Stellaris[®] LM3S1J16 RevB1 Errata

This document contains known errata at the time of publication for the Stellaris[®] LM3S1J16 microcontroller. The table below summarizes the errata and lists the affected revisions. See the data sheet for more details.

Figure 1. Workaround Circuit to Ensure Initial Power Up

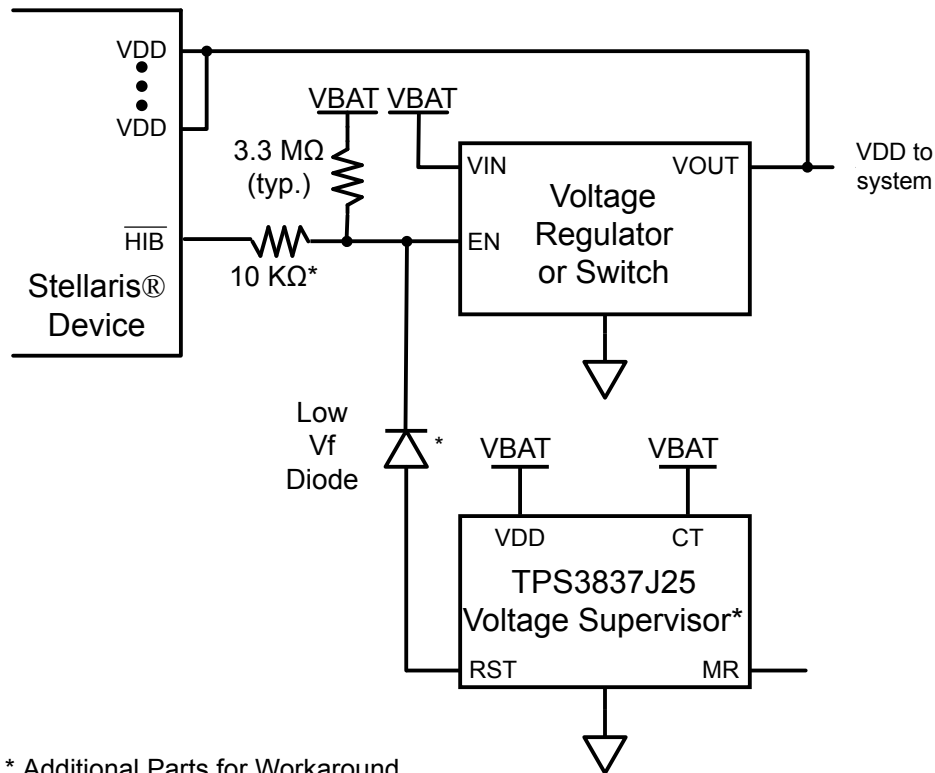
If V_{DD} is not powered when voltage is first applied to V_{BAT} , the state of the Hibernation module is indeterminate and the \overline{HIB} signal may be asserted. In this indeterminate state, a lock condition can occur in which the Hibernation module waits for a power-on-reset, but that reset cannot occur until the module deasserts \overline{HIB} . This issue is related to the errata "Hibernation module may have higher current draw than specified in data sheet under certain conditions" on page 5.

The workaround implementation depends on the system-level power supply configuration. For systems that use a battery as the primary power source, an external voltage supervisor (TPS383J25DBV or similar) circuit can be added to force the V_{DD} power supply to start when the battery voltage is first applied (see Figure 1). The voltage supervisor requires only 220 nA and generates a 200-ms positive pulse to turn on the V_{DD} regulator and activate the microcontroller's internal POR circuit.

Figure 2. Configuration of External Regulator

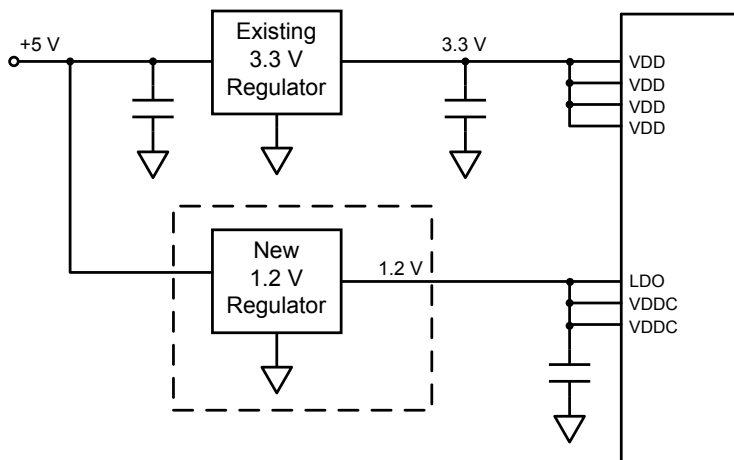
Incorrect power sequencing during power up can disrupt operation and potentially cause device failure.

V_{DDC} must be applied approximately 50 μ s before V_{DD} . Normally V_{DDC} is controlled by the part's internal LDO voltage regulator. The workaround requires the addition of an external regulator (see Figure 2) to ensure that V_{DDC} sequencing requirements are met (see Figure 3). Recommended regulators include FAN1112SX (SOT223) and FAN2558S12X (SOT23-5).

This fix mitigates the on-chip power issue, but does not solve it completely. During development, the Flash memory should also be reprogrammed (using LMflash or another programming tool) at least once a week.
